SAN FRANCISCO PLANNING DEPARTMENT

Addendum 3 to Environmental Impact Report

Case No.: **2011.0558E**

Project Title: **Transit Effectiveness Project, Modified Expanded TTRP.8,
Segment on San Bruno Avenue**

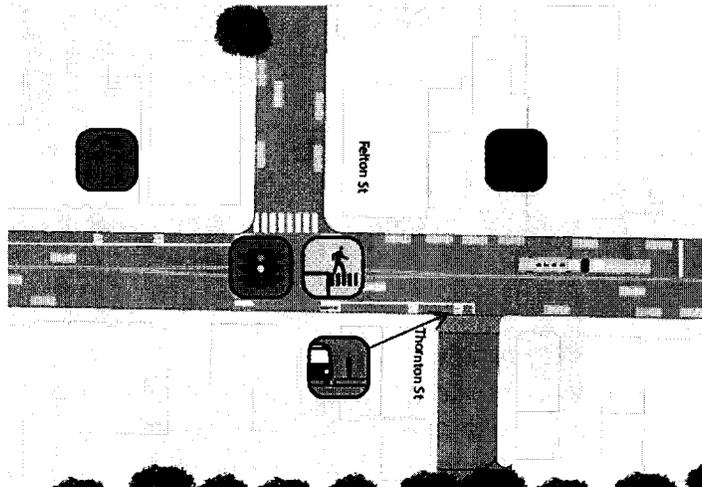
- 1. *Transit Stop Modifications:*** The Expanded TTRP.8X Alternative in the EIR would extend the existing inbound bus zone on San Bruno Avenue at Silver Avenue from 105 feet to 125 feet; instead the modified project would construct a six-foot wide and 200-foot long transit bulb. The currently proposed transit bulb would replace the Moderate Alternative's recommendation for a right turn pocket/signal queue jump in front of the bus zone. The implementation of the 200-foot long transit bulb would remove five parking spaces resulting in no change from what was analyzed in the EIR for the bus zone extension and right turn pocket, which would no longer be implemented. The Modified Expanded TTRP.8 would retain the inbound bus stop at Wayland Street proposed for removal in the EIR, and the resulting additional three parking spaces that would have occurred with the Moderate

Alternative under the EIR would not occur. In the EIR, the Expanded TTRP.8X included a 20-foot sidewalk extension/raised crosswalk across Thorton Street to accommodate a longer bus zone. The Modified Expanded TTRP.8 Alternative would include a sidewalk extension of 34 feet to act as a “raised crosswalk/bus stop,” as depicted in the below figure.
